Elevator Idler Fatigue Cracks

EFFECTIVITY**MODEL-** Ranger R7**SERIAL NO:** 10131-10227

Rev A	-INITIAL RELEASE
REV B	-SERIAL NO. Effectivity Revised -METHOD OF COMPLIANCE updated to show corrective action with upgraded design

Figure 2

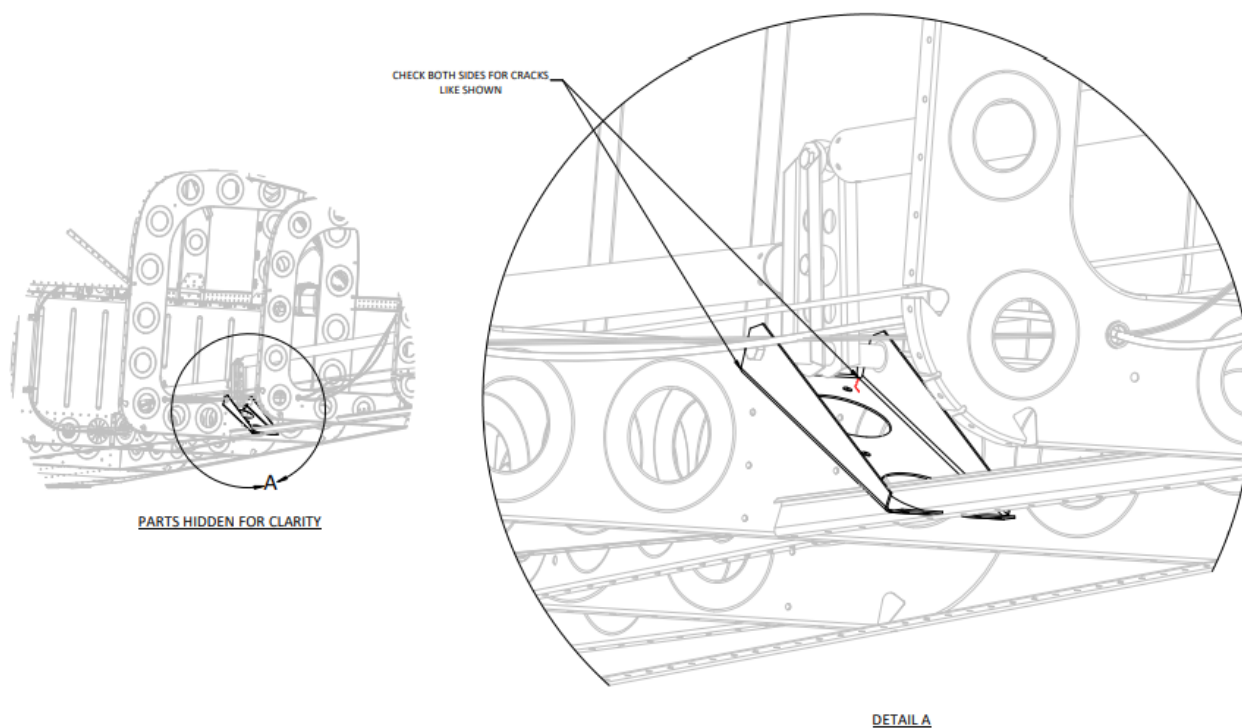
Inspect the critical flanges as shown in Figure 2 and Figure 3. If any cracks are present, replace parts with upgraded design.
